## Reviewers #1

*RC. This paper documents an important dam breach event (Niedów dam-breach) that occurred in 2010 during an extreme synoptic rainfall event that involved a large watershed. The test case is interesting although it could be better documented.*

Fig. 1. The catchment of the Witka River

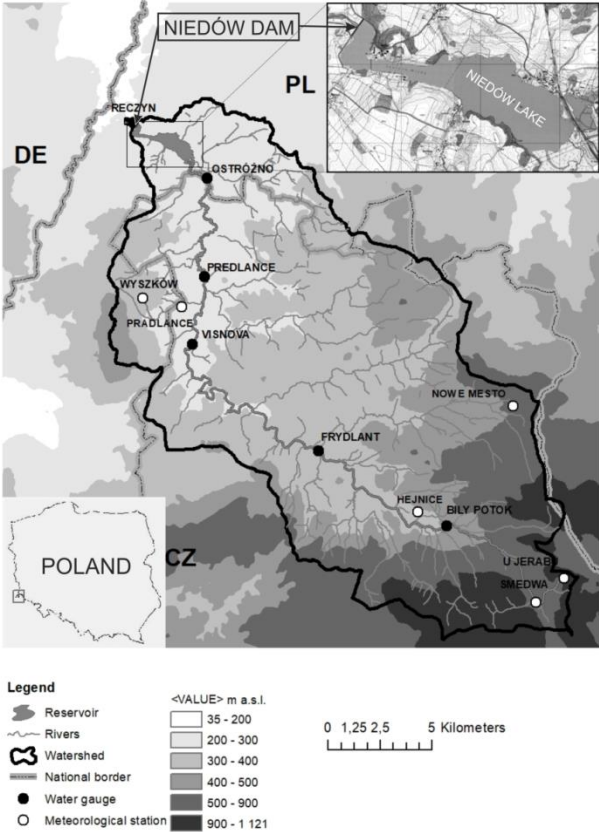
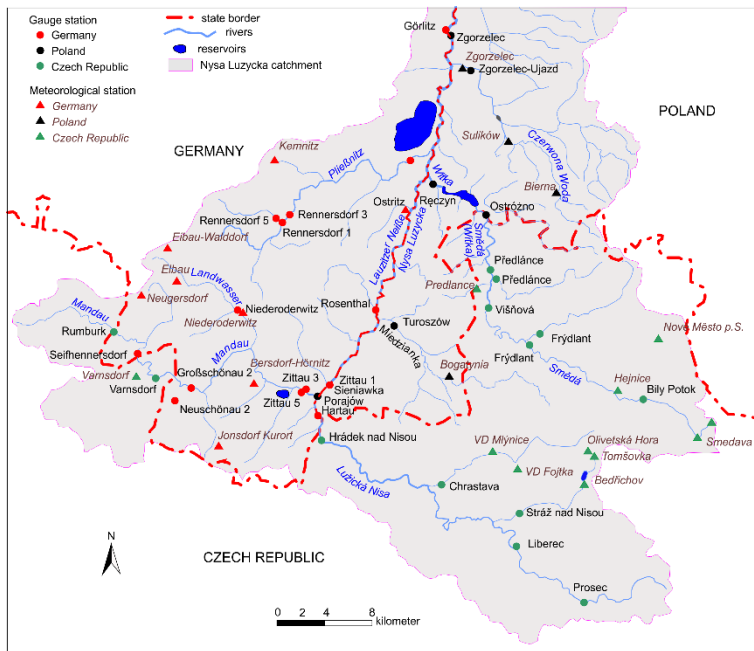
Fig. 1. Improve: add numbers indicating Witka river, the Miedzianka river and Lusatian Neisse river which are mentioned in the paper but missing in the Figure Moreover, no indication appears here about the area studied in the 2D modeling, that pops up only in Figure 9

The figure is modified, including an enlarged plan view of the reservoir. Additional figure showing the Lusatian Neisse river catchment and river network is provided:

Fig 3. s adapted as below:

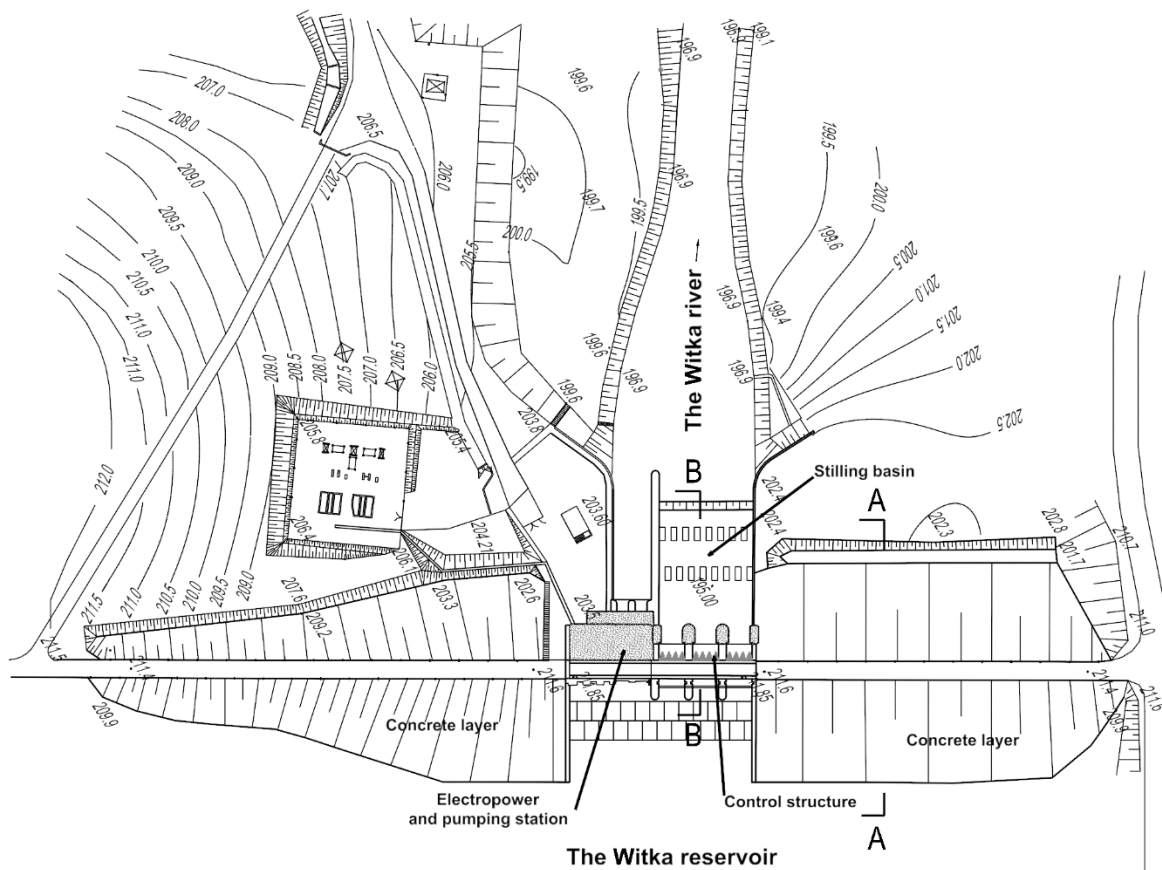
Figure 3. *Add major dimensions on the blueprint and dashed lines to show the location of the cross section shown in Fig. 4 and 5*

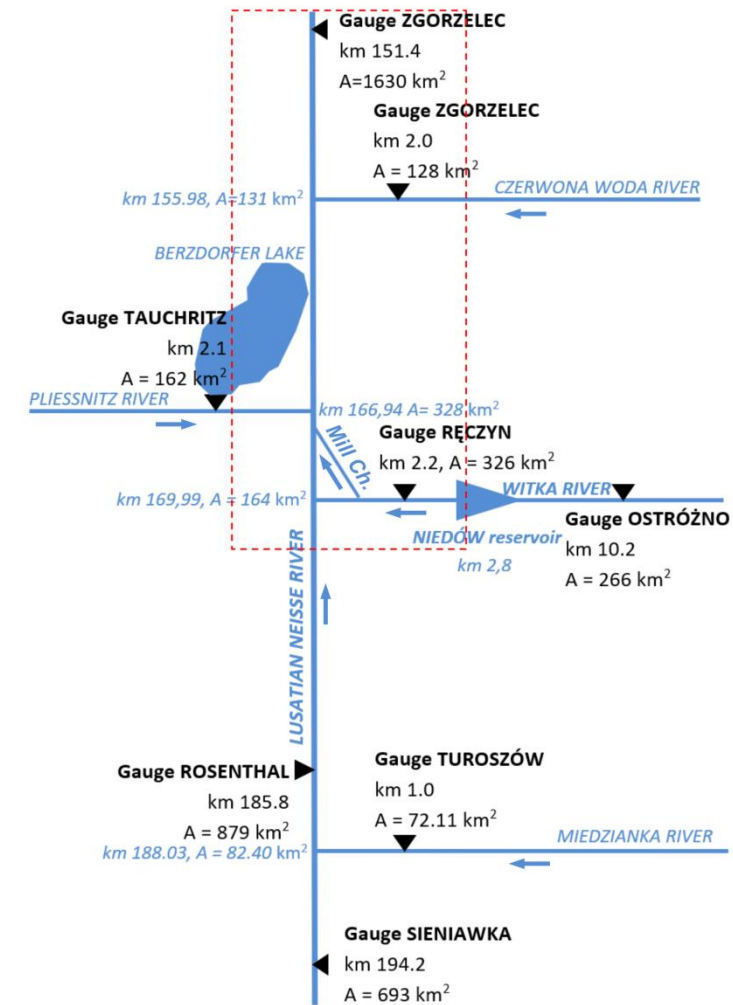
*In the figure there are red marks underneath the names of the locations reported typical of a grammatical check tool, their presence is unessential. Furthermore the schematics provided is very helpful in understanding the domain in which the numerical method is applied, but the lack of a geographical counterpart of the same scheme (a map with all the locations highlighted) damages the understanding of the spatial dimensions involved in the simulation. As previously noted, a map is required to help the reader to orient himself in the various locations described in the current work.*

Figure 9 is corrected (below) and a catchment map is added as Fig 2.
